SUBJECT: ISSUANCE OF AMENDMENT NOS. 27 AND 17 TO FACILITY OPERATING  
LICENSE NOS. NPF-76 AND NPF-80 - SOUTH TEXAS PROJECT, UNITS 1  
AND 2 (TAC NOS. 79390, 79391, 74891 AND 74892)

SOUTH TEXAS PROJECT, UNIT 1

Amendment No. 27  
License No. NPF-76

ATTACHMENT TO LICENSE AMENDMENT NOS. 27 AND 17  
FACILITY OPERATING LICENSE NOS. NPF-76 AND NPF-80  
DOCKET NOS. 50-498 AND 50-499

Figure 3.1-2a

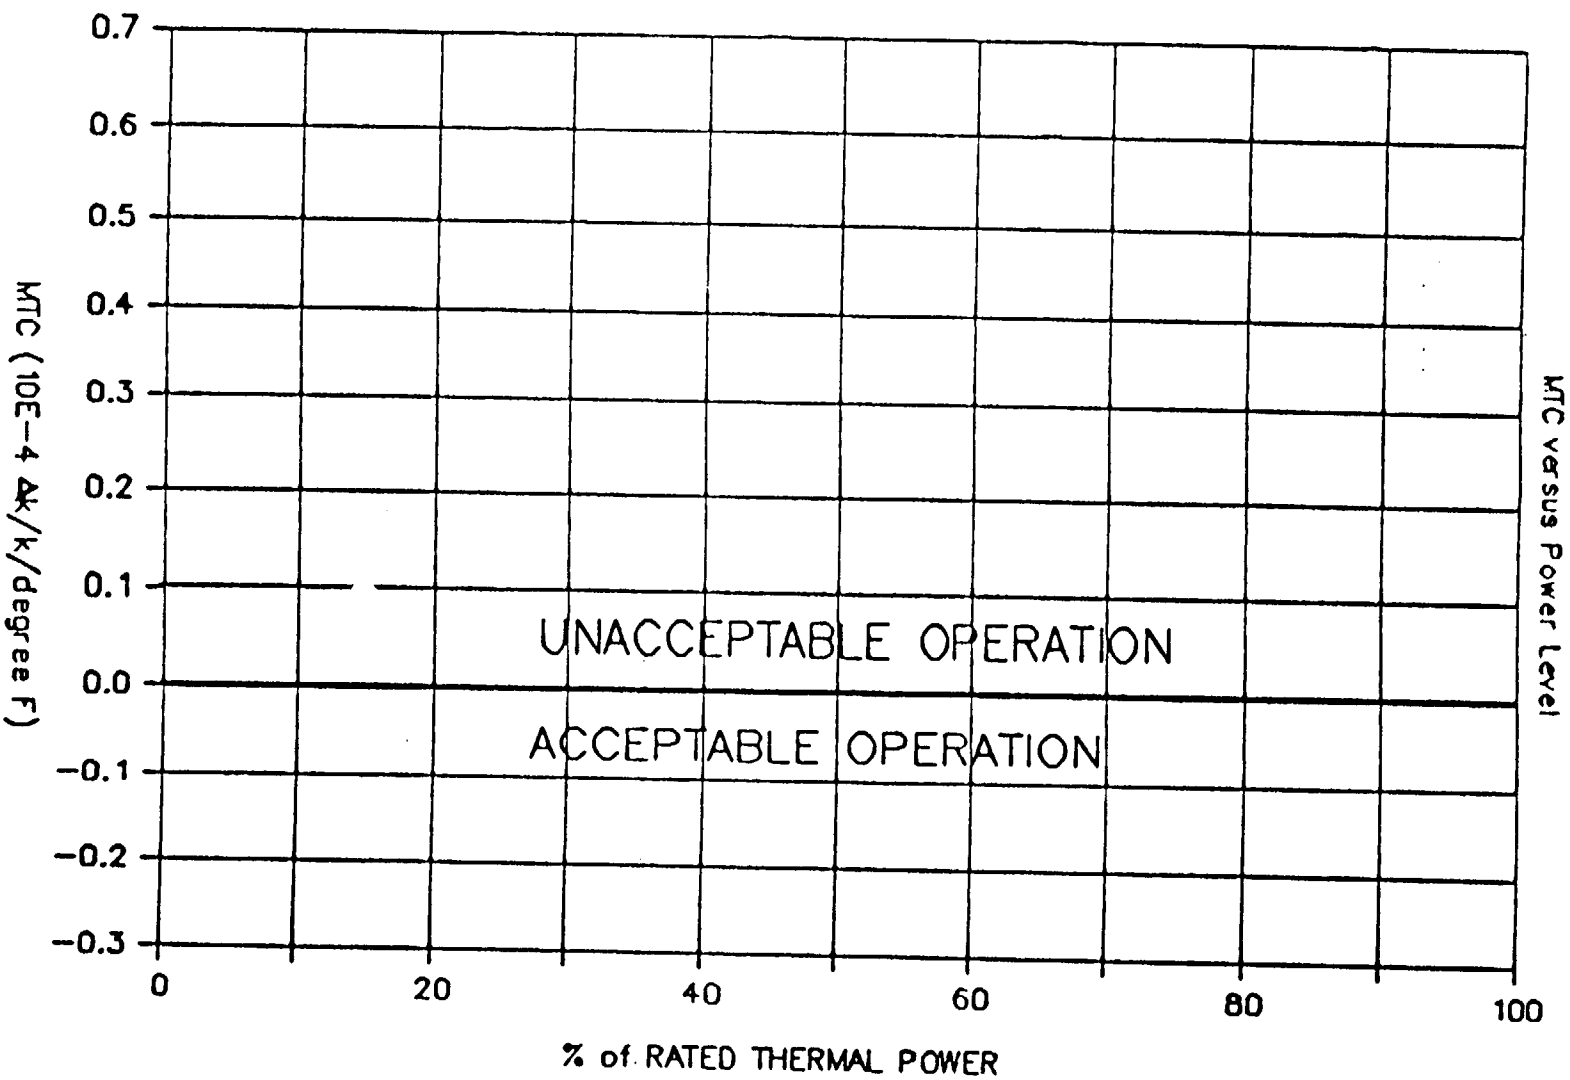
3.1.1.3 The moderator temperature coefficient (MTC) shall be within the limits specified in the Core Operating Limits Report (COLR). The maximum upper limit shall be less than or equal to that shown in Figure 3.1-2a.
